**ZEE Systems, Inc.**

***SERVICE BULLETIN R134-06***

1.0 EFFECTIVITY: DC-3 aircraft that have been modified in accordance with Basler Turbo Conversions STC SA1734GL for the installation of ZEE Systems, Inc. air conditioning equipment.

2.0 PURPOSE: To modify the air conditioning system to use R-134a refrigerant.

DIP STICK

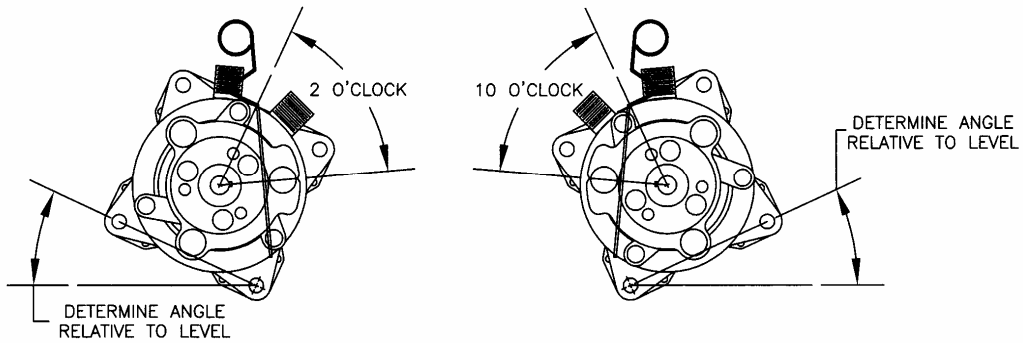
9.2.1.2 The compressor is supplied serviced and ready to use. To check the oil level in the compressor, fabricate a dip stick as shown below. Determine angle of the compressor relative to level. Align the clutch as shown below. Remove the oil fill plug at the top of the compressor. Insert the dip stick and determine oil level using TABLE 1. Add oil as necessary. Replace the oil fill plug.

ANGLE	ACCEPTABLE OIL LEVEL	
	mm	INCHES
0	9 - 15	.35 - .59
10	12 - 18	.47 - .71
20	15 - 21	.59 - .83
30	18 - 24	.71 - .94

WIRING DIAGRAM 1.

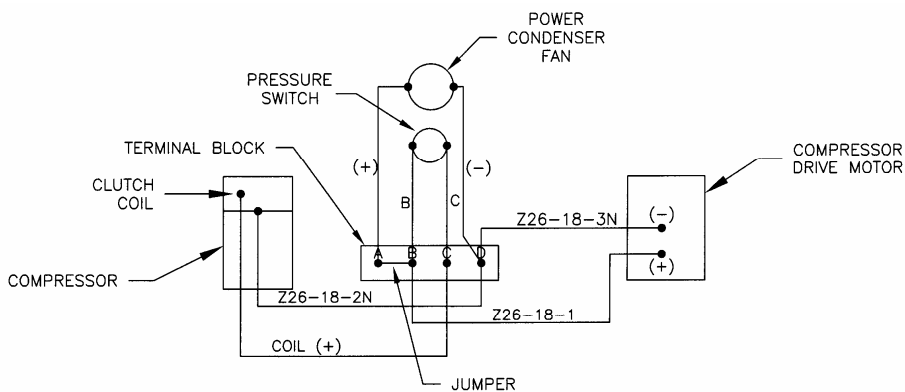
10.3.2 To check to compressor clutch you will need to by pass the Z99-032 High/Low Pressure Switch. Remove COIL (+) wire from C post on the terminal block. Apply 28 VDC to COIL (+) wire with any ground. The clutch should pull in with an audible click. After test return wire COIL (+) to C post of the terminal block.

***DO NOT CHECK THE CLUTCH OPEERATION BY APPLYING POWER DIRECTLY TO POST C ON THE TERMINAL BLOCK. DAMAGE TO WIRING MAY OCCUR AS A BACK FEED MAY TRY TO ENERGIZE THE COMPRESSOR DRIVE MOTOR.***
